Delegated Report		Analysis sheet		Expiry Date: 28/04/2023	
		N/A		Consultation Expiry Date: 19/03/2023	
Officer			Application Number(s)		
Ewan Campbell			(i) 2022/5552/P (ii) 2023/0920/L		
Application Address			Drawing Numbers		
Stables building in the land to the rear of Hampstead Police Station 26 Rosslyn Hill London NW3 1PD			Please refer to draft decision notice		
PO 3/4	Area Team Signature	C&UD	Authorised Officer Signature		
Proposal(s)					
<p>i) Variation of condition 2 (approved plans) and removal of condition 7 (green roof) of planning permission 2022/0329/P granted on 01/03/2022 for 'Change of use and refurbishment of the Stables building and internal alterations to provide residential accommodation, alteration of the flat roof to provide skylights and adequate insulation, installation of solar PV panels, the opening of windows previously blocked on the side elevation and the installation of a rear dormer window at roof level', namely to include removal of original slates and replacement with grey slates, installation of solar slates on rear pitch, removal of green roof, relocation of roof lantern, addition of solar panels and relocation of Air Source Heat Pump (part retr

Figure 4: Rear Elevation showing solar slates location

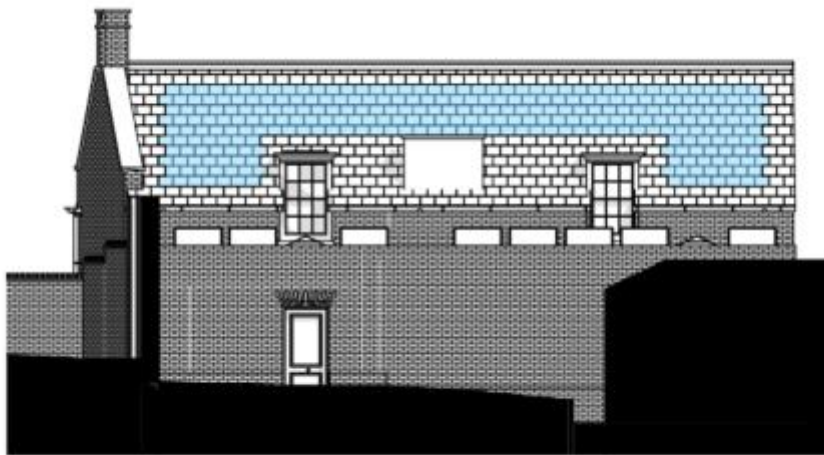
1.1.2. The solar slates on the rear elevation are related to this point as they also involve the removal of original slates (see *figure 4* below demonstrating their location). The use of solar slates is not acceptable on this listed building as these items result in a loss of historic fabric and are visually dissimilar from natural slates. Whilst renewable energy measures are supported by the Council, this benefit needs to be balanced by the impact on the setting and character of the listed building. The result is the removal of historic slates which can be seen in multiple private views and the introduction of solar panels within the proposal which contribute towards energy efficiency. However their use in this location does not outweigh the harm caused by the associated removal of slates here. Notwithstanding this, the use of solar slates in this location, even without the presence of other solar panels, would not be supported. The fact that they have been used to replace the historic green slates compounds the issue and means the introduction further detracts from the character of the listed building.

1. Completely remove the grey Welsh roof slates from the roof of the Stables building; and
2. Reinstate green Westmorland slates to match the size, pattern and method of installation of those previously in place.
